Amendment 39-4658; AD **82-20-01**

Airworthiness Directives; BENDIX: Applies to Bendix Engine Products Division Magnetos
PDF Copy (If Available):

82-20-01 BENDIX: Amendment 39-4658. Applies to Bendix Engine Products Division magnetos with type designations listed below:

FIGURE 1

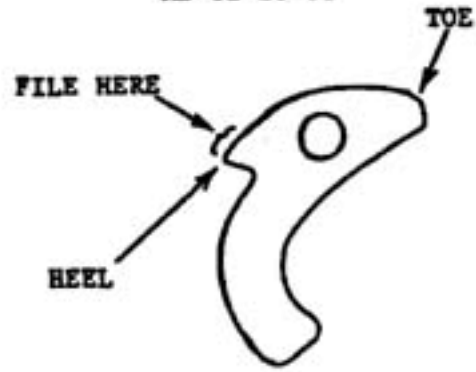
3. Use finger pressure to push inward on the toe (see Figure 1) of each flyweight so that the flyweight heel protrudes outward.
4. Using a fine #1, double cut, 1/2-inch wide file at least 3/32-inch thick, pass the file across the heel of the flyweight attempting to remove material (see Figure 1). If the flyweight has been properly heat treated, the file will "glide" smoothly over the heel of the flyweight, removing no material. If the flyweight is not properly heat treated (soft), the file will not "glide" easily across the surface of the flyweight heel, and material will be removed.

5. If an improperly heat treated (soft) flyweight is found, immediately remove and replace the cam assembly and/or the impulse coupling assembly with an assembly meeting the requirements of this AD, following procedures in the magneto overhaul instructions, and paying strict attention to notes and cautions.
